RE: Commercial Source Material
License Application, Docket
No. 40-8745

SUBJECT: NRC/OPI Meeting on
October 7, 1980

BISON BASIN PROJECT
 BISON BASIN MINE
 MONITOR WELL LOCATIONS
 MINING UNIT NO.1

ATTACHMENT I

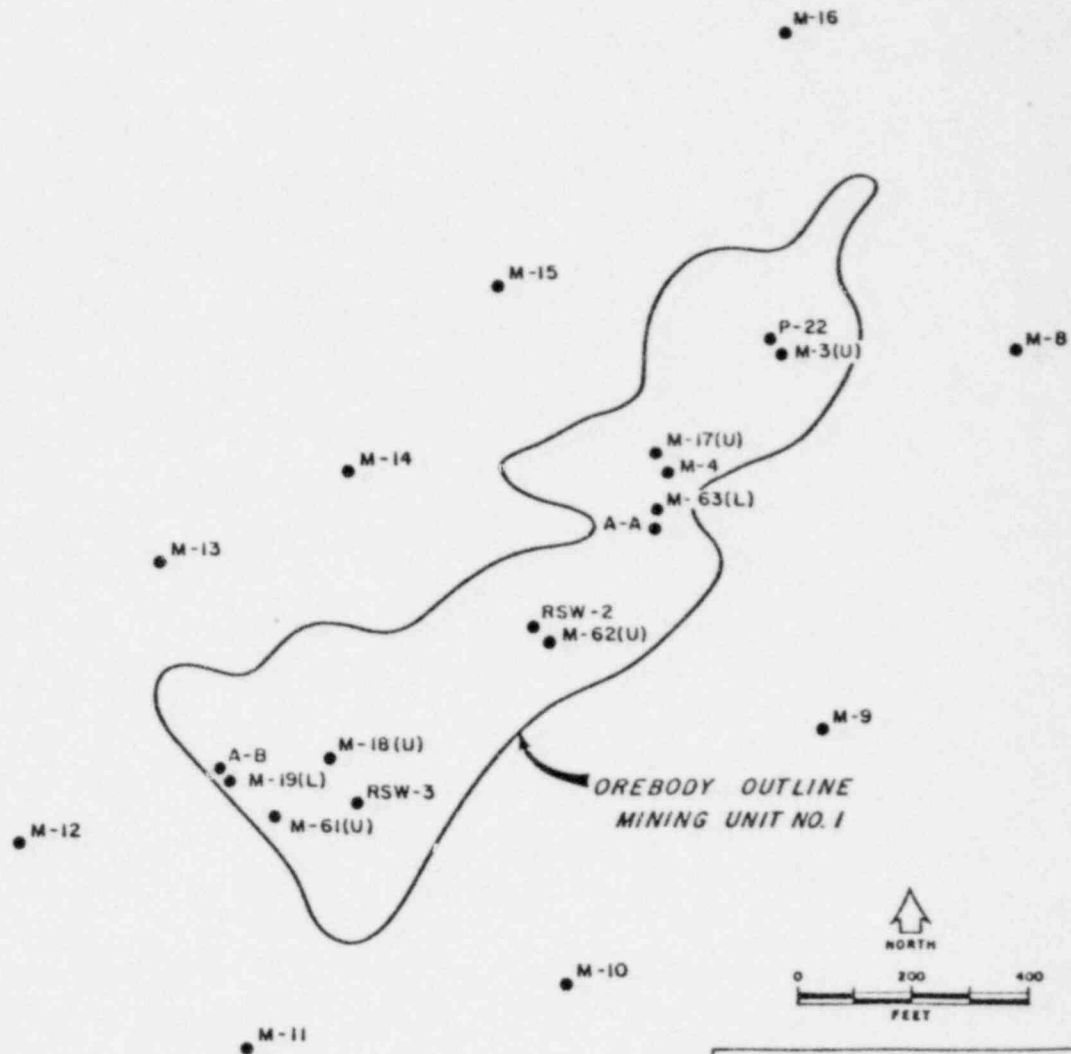
1. Pump Test No. 4 will consist of pumping lower monitor well M-19 for ten hours at a constant rate and monitoring the drawdown in well M-18 (upper aquifer), well RSW-3 (ore zone), and Well A-B (ore zone) all of which are located on the attached map (Attachment I). Yield and specific capacity will be reported for the pumped well (M-19) along with the drawdown (if any) for the above-mentioned observation wells. If it is not possible to pump M-19 at a constant rate for ten hours, then RSW-3 (or A-B) will be pumped and M-19, M-18, and A-B (or RSW-3) will be used as the observation wells. Analysis of the resulting data will be performed in accordance with Mr. Miller's September 8 letter.

2. Pump Test No. 5 will consist of pumping lower monitor well M-63 for ten hours at a constant rate and monitoring the drawdown in well M-17 (upper aquifer), well M-4 (ore zone), and well A-A (ore zone) all of which are located on Attachment I. Yield and specific capacity will be reported for the pumped well (M-63) along with the drawdown (if any) for the above-mentioned observation wells. If it is not possible to pump M-63 at a constant rate for ten hours, then M-4 (or A-A) will be pumped and M-63, M-17, and A-A (or M-4) will be used as the observation wells. Analysis of the resulting data will be performed in accordance with Mr. Miller's September 8 letter.
